Planning Commission - Staff Report

Subject: MSC2024-0037 Northern South Park Area I Master Site Plan Application

RE: UPDATED Plan Review Committee Comments – MSC2024-0037 Northern South Park (Area 1) Master Site Plan – revisions/updated submittals dated 1/17/2024

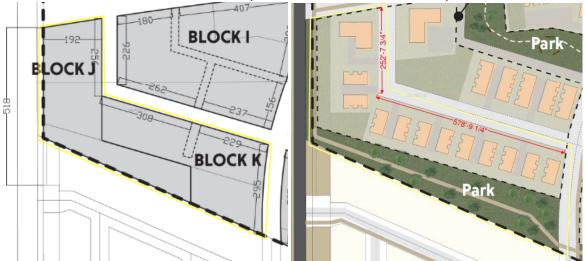
Complies as conditioned. The term and definition of "Block" is unique to the NSP overlay and is intended to achieve the neighborhood characteristics and connectivity identified in Neighborhood Plan and replicate the pattern of development more common in the Town of Jackson east of Karns Meadow. A Block, per Sec. 4.5.2.B.1., is, "[a]n area of land defined by adjacent, publicly-accessible streets and/ or pathways." There are then three substandards related to block faces.

- a. Block faces are defined between publicly-accessible streets or pathways and measured between the nearest edges of publicly-accessible rights-of-way or easements.
- b. External Block Faces. External block faces are defined as blocks facing High School Road, South Park Loop Road or Jackson Hole High School. External block faces shall not exceed 600 feet.
- c. Internal Block Faces. Block faces internal to Northern South Park, not facing High School Road, South Park Loop Road or Jackson Hole High School, shall not exceed 450 feet.

The proposed Block Plan demonstrates a certain conceptual compliance with the block dimension requirements, based off the rough level of detail available at this time. All of the external block faces are less than 600 feet. Some of the blocks are illustrated as divided by future internal pathways and/or alleyways internal to the block, the final locations of which would not be determined or guaranteed until Development Plan. There are also some adjacent blocks where the boundary between the two does not appear to be fully identified by a street or pathway, such as Blocks J and K illustrated below. However, then in the concept plan the envisioned layout, which is not binding, looks like a single cohesive neighborhood block. This may not be an issue, so long as final development on both blocks can follow the NSP-2 standards, nevertheless, staff wants to stress that a publicly accessible street or pathway is required to delineate the internal northeast block face which would otherwise measure 550+ ft in length. A dead-end driveway or alley way to an apartment or condo building is not necessarily publicly accessible, nor does it achieve the connectivity goals and spirit of the neighborhood plan. The street or pathway in question shall provide access through the block, or to a public park, to meet the intent of "publicly-accessible" in the block definition. In the example below, an additional pathway running north-south to connect to the park/pathway network could achieve the desired block separation and be added at Development Plan.

The purpose of limiting the external and internal block faces is to create the walkable neighborhoods envisioned by the Neighborhood Plan. Staff want to highlight these concerns now, since the parts of the Concept Maps which illustrate hypothetical block-level development, like building locations and alleyways not included in the Road Network Plan, are not yet determined. While we are not reviewing the development within the blocks yet, it would be helpful for the applicant to receive this feedback now, rather than later, to incorporate into their future Development Plan preparations. Therefore, staff have recommended a condition of approval to ensure there are no assumptions regarding future compliance with the Block definition and standards in Section 4.5.2.B.1.

- **3.** All future blocks shall demonstrate compliance with the standards of LDR Section 4.5.2.B.1., specifically Internal Block Faces, as reviewed at the time of Development Plan.

APPENDIX 2: Pedestrian Facilities

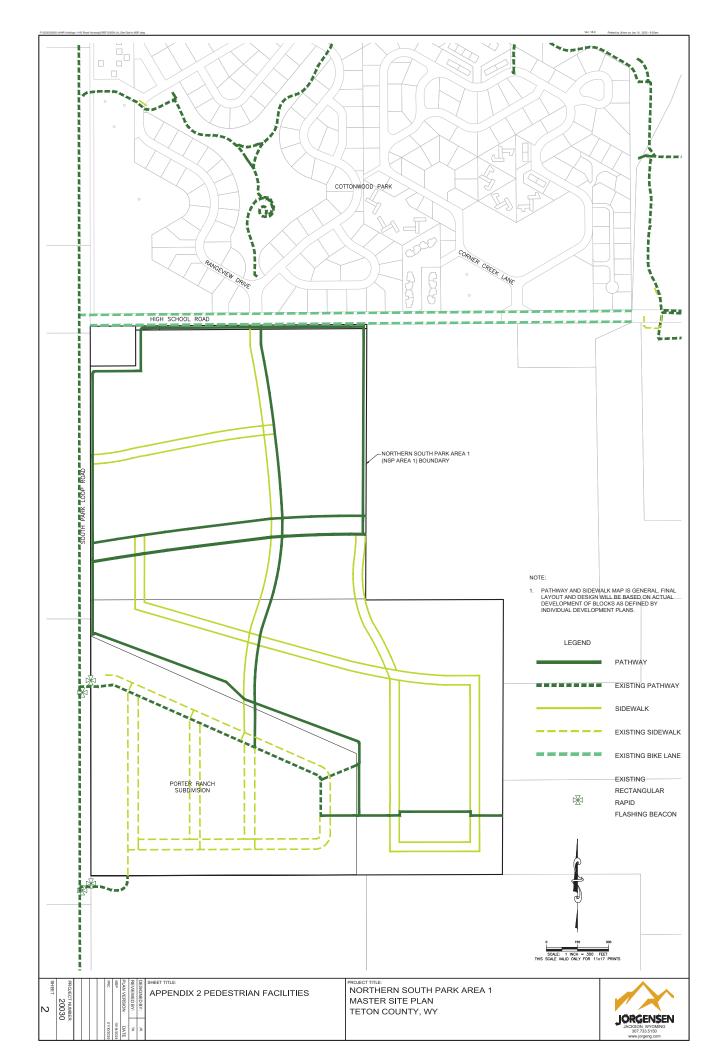
Requested some modifications to the pathway plans which were included by the applicant in the updated 10/17/25 submittal
